3028624-LU

12727 30th Ave NE

Recommendation Design Guidance Meeting

Meeting Date: March 30, 2019

SOUTH ELEVATION

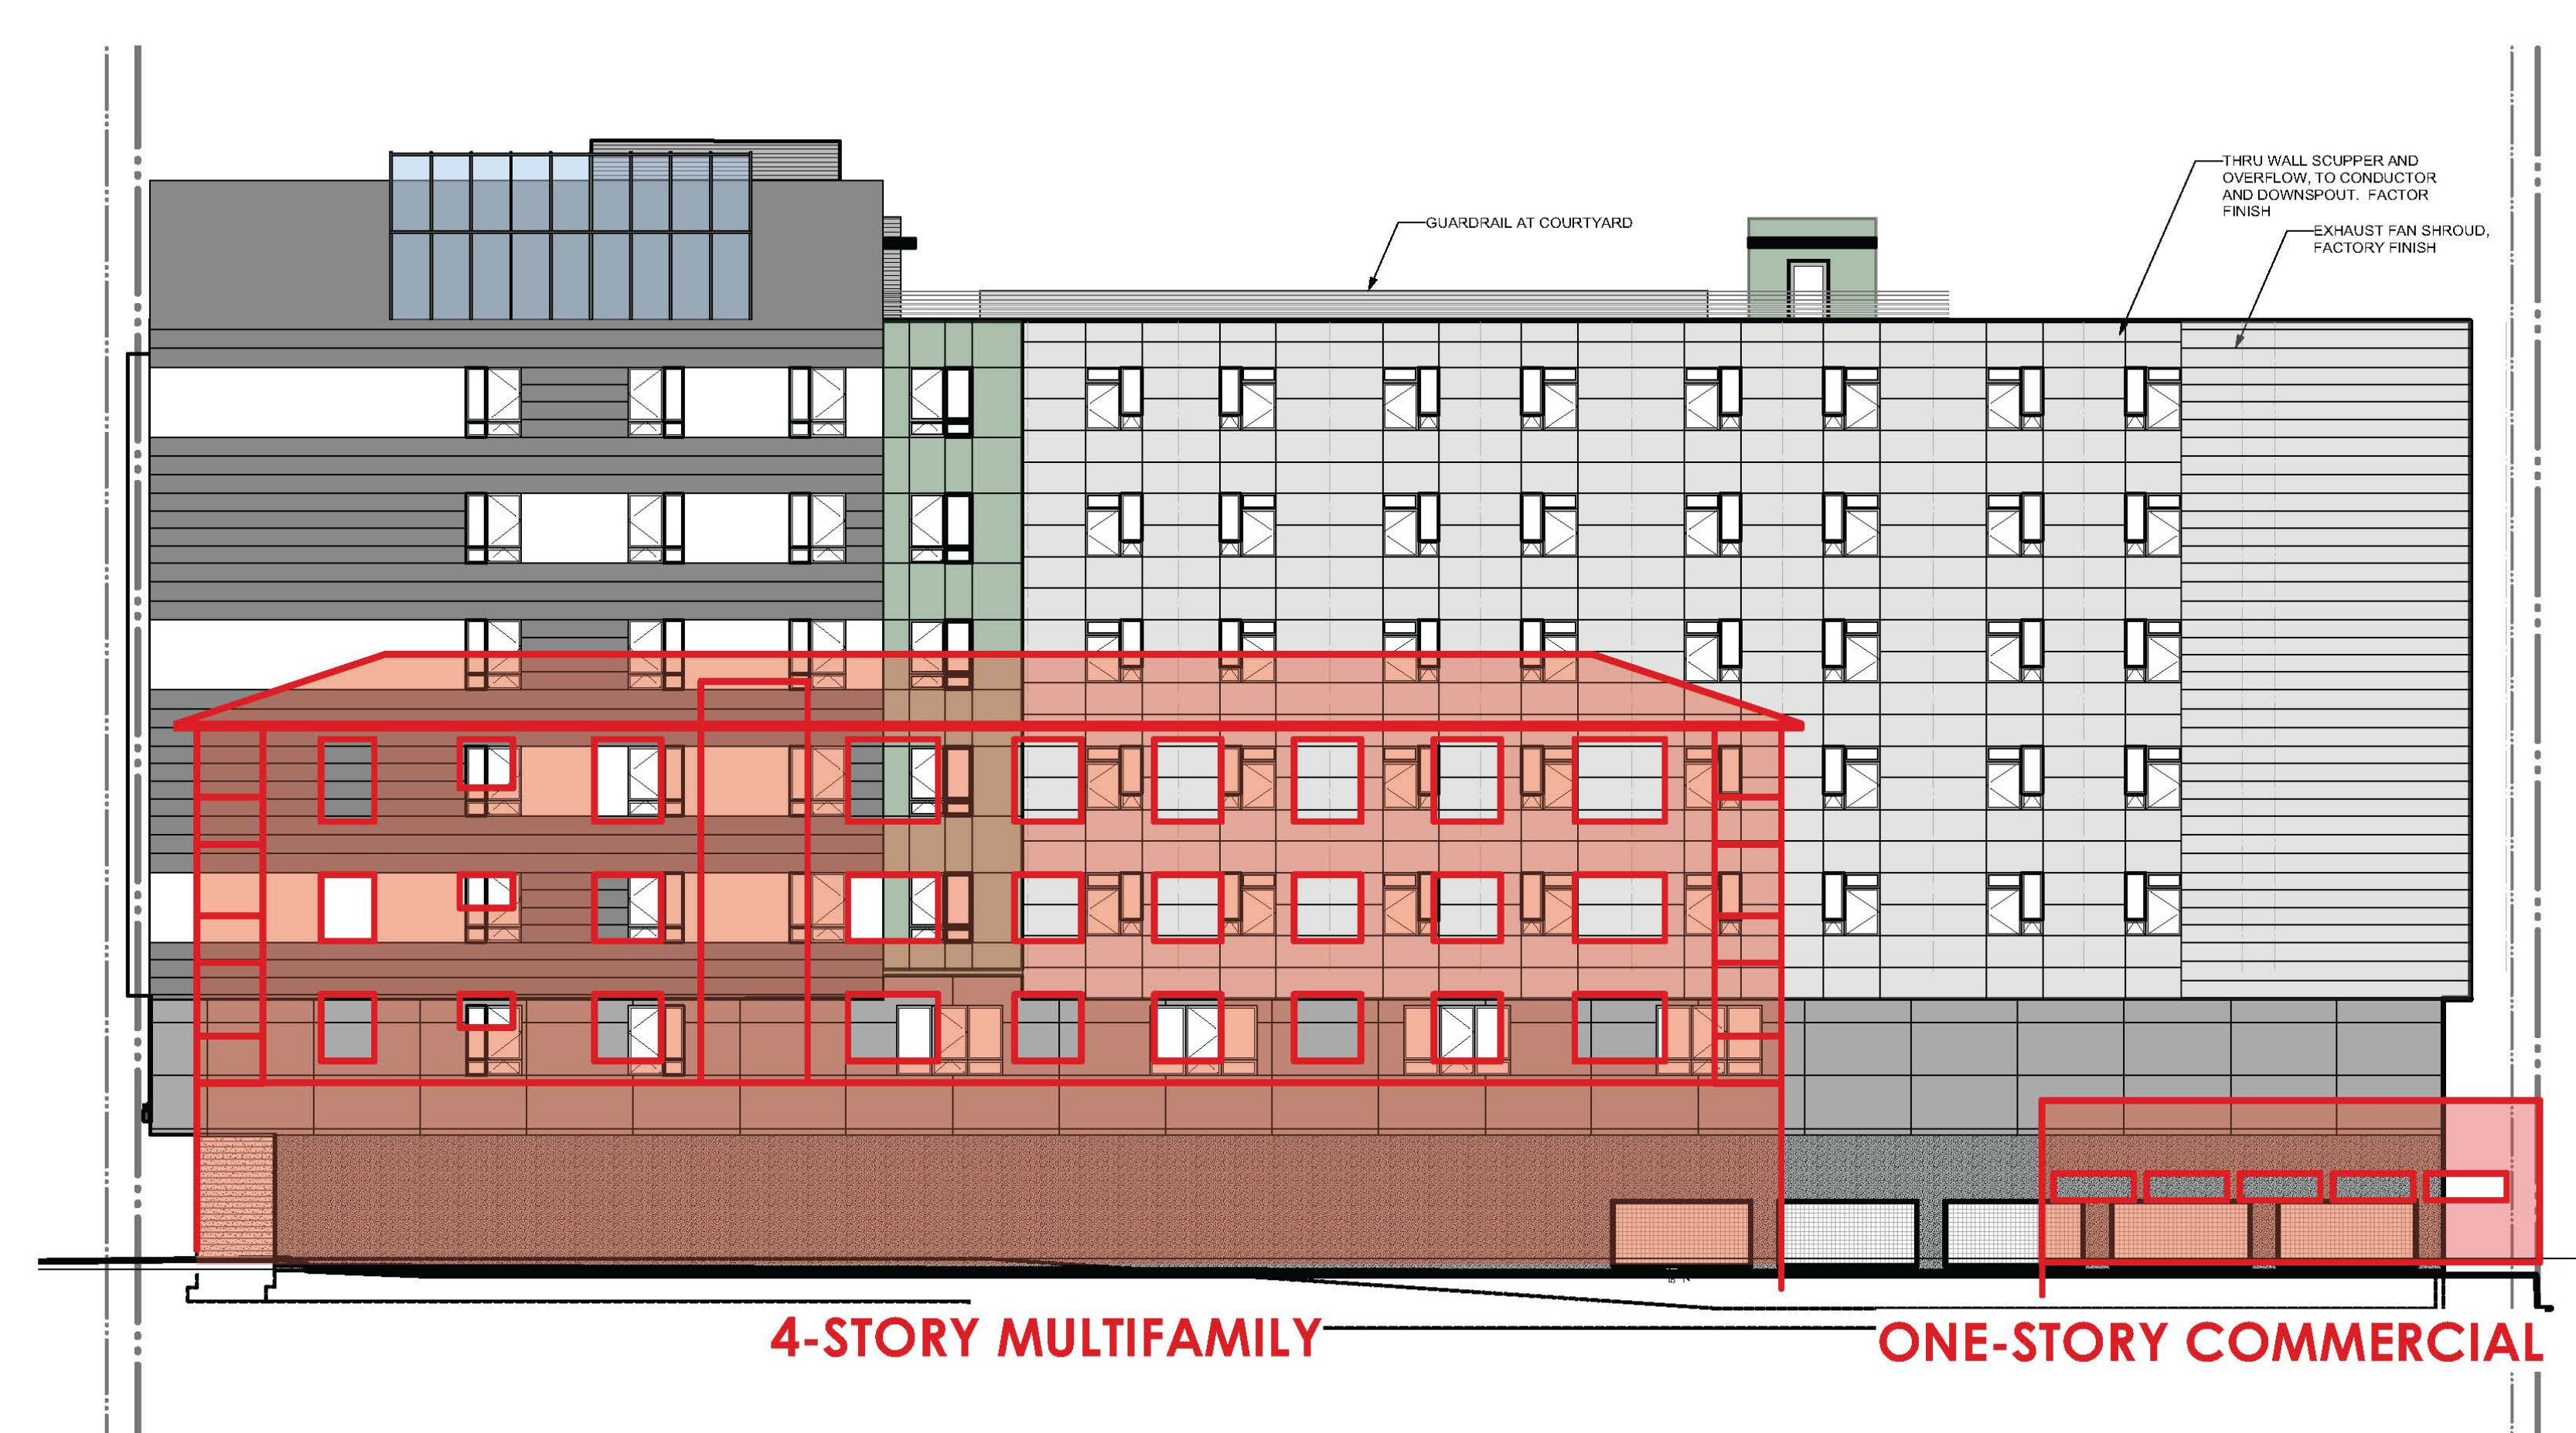
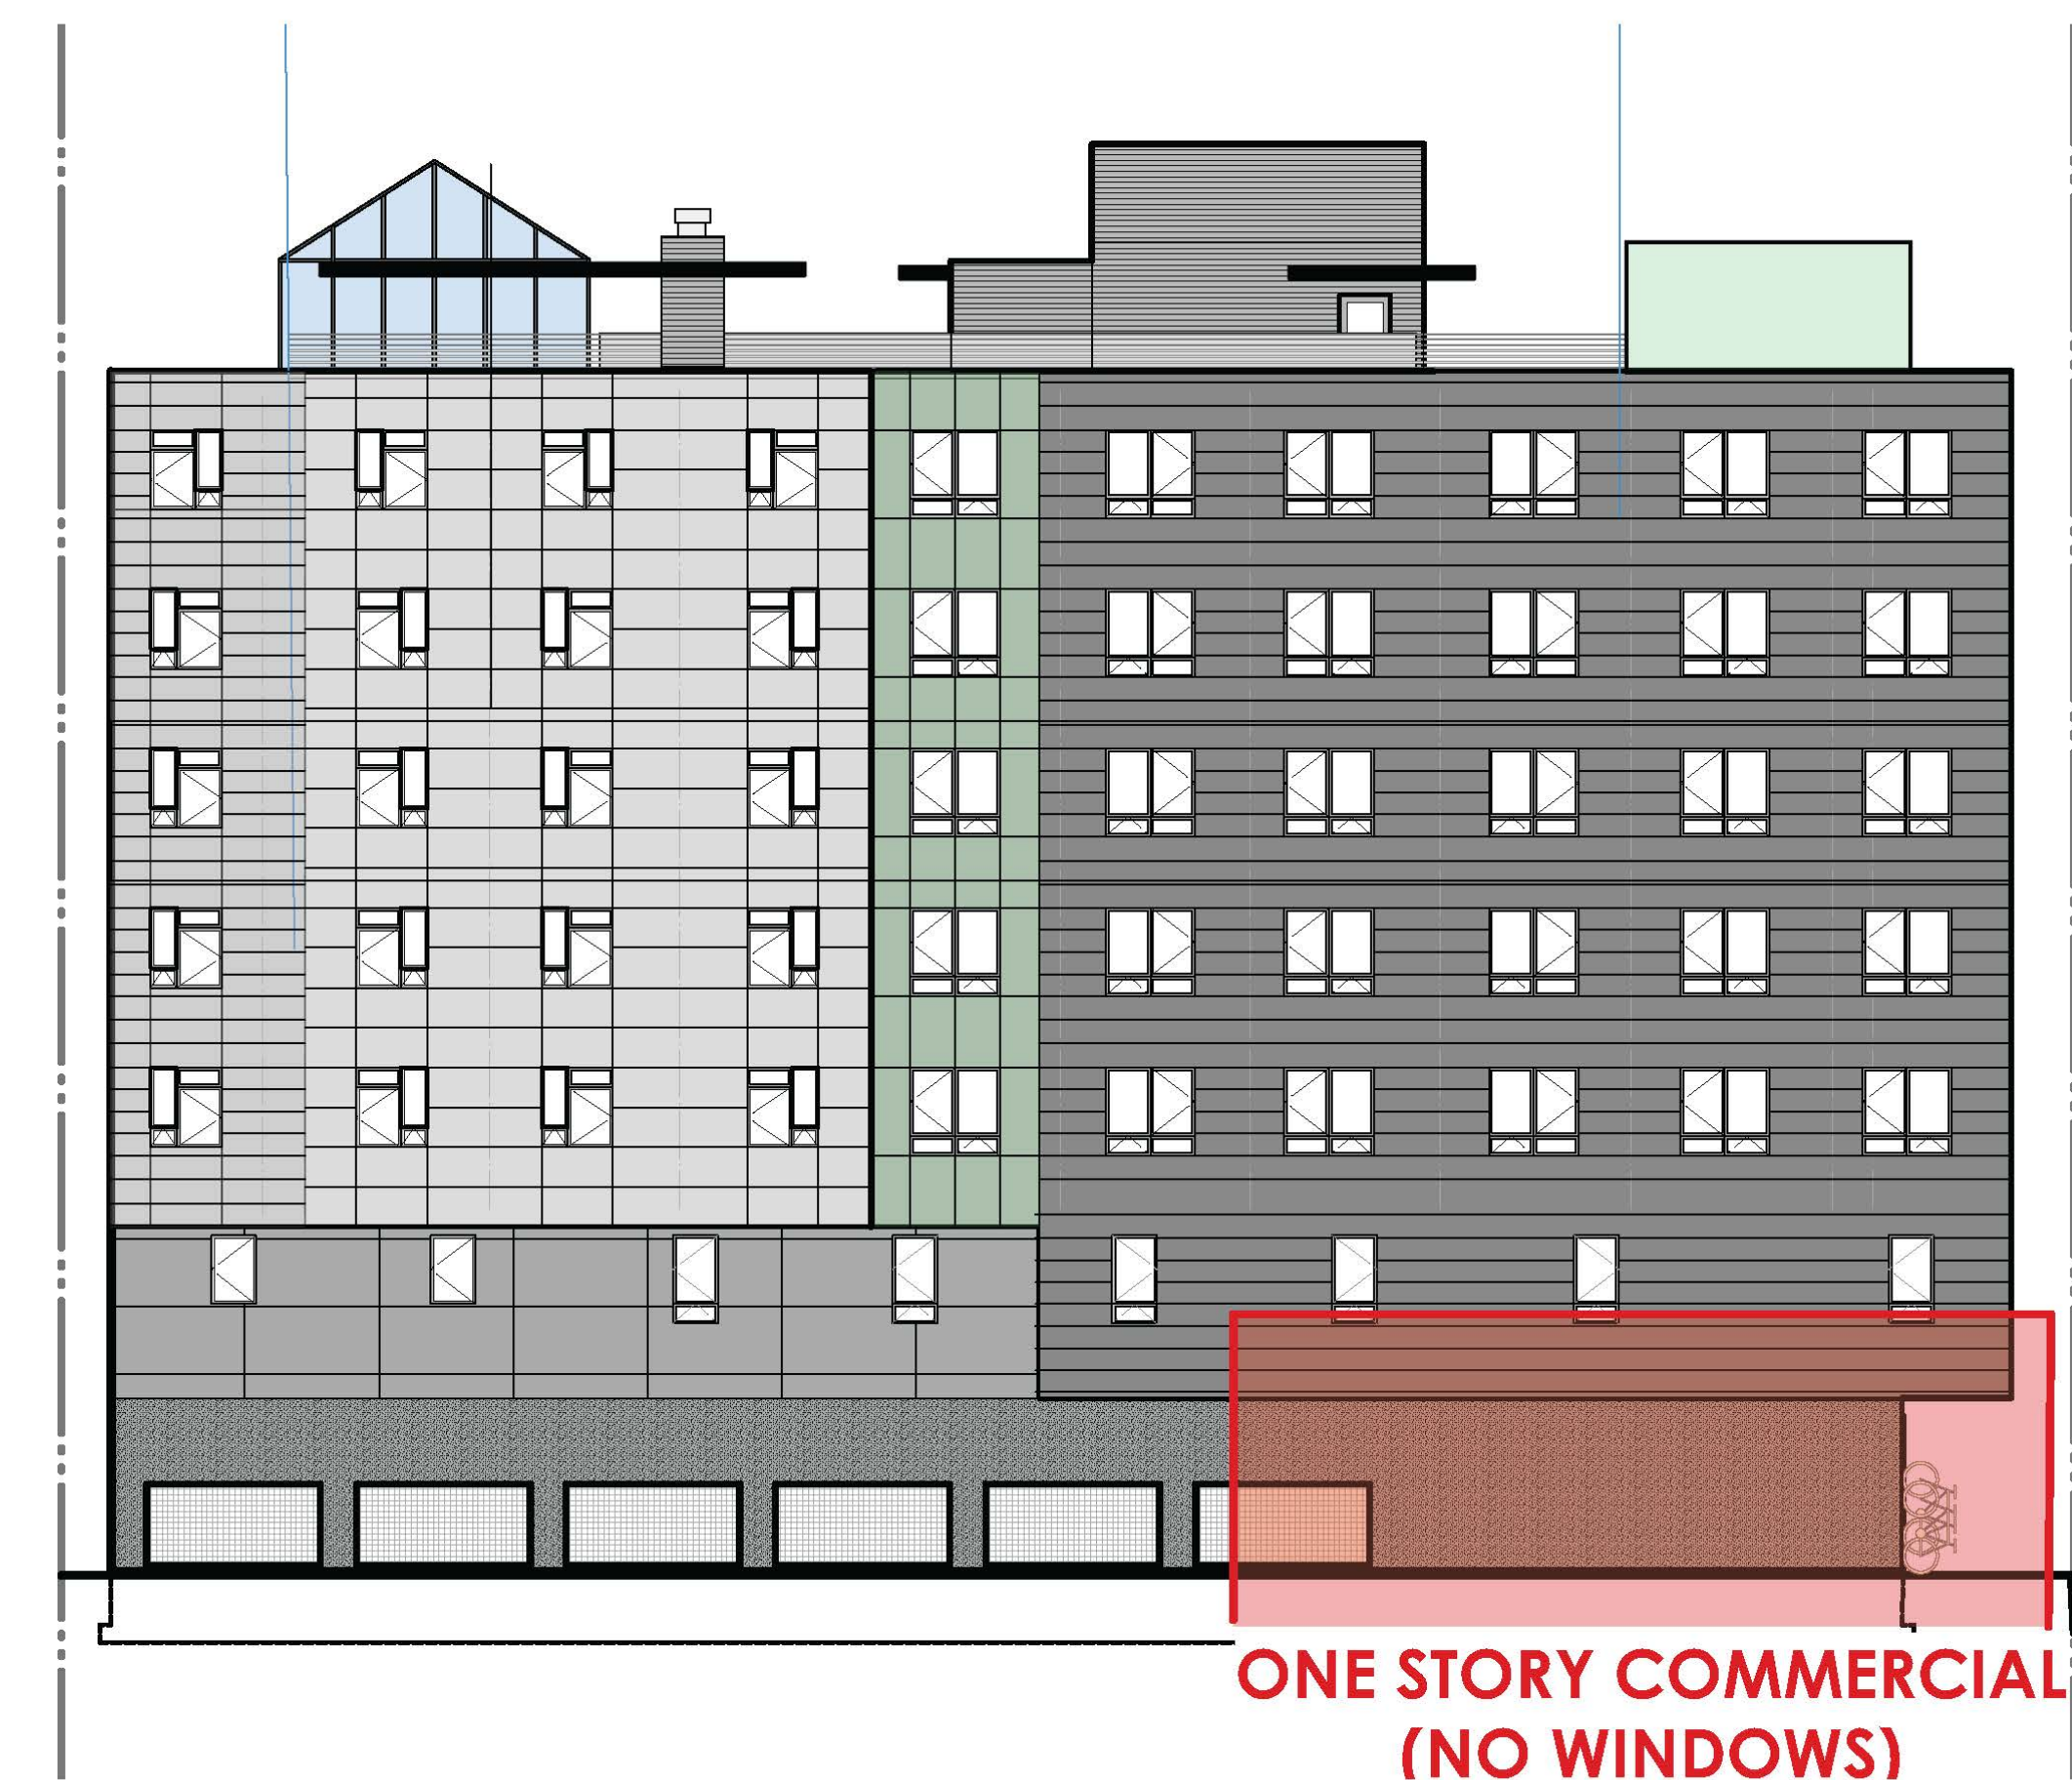
The Board requested a window overlay study.

- Window overlay study is provided.
- Adjacent buildings to the south and west will see little to no impact from proposed window locations.
- North building appears to have windows opposite proposed window locations. Given the narrow sizing of the proposed efficiency units it is difficult to adjust a great deal within the units.
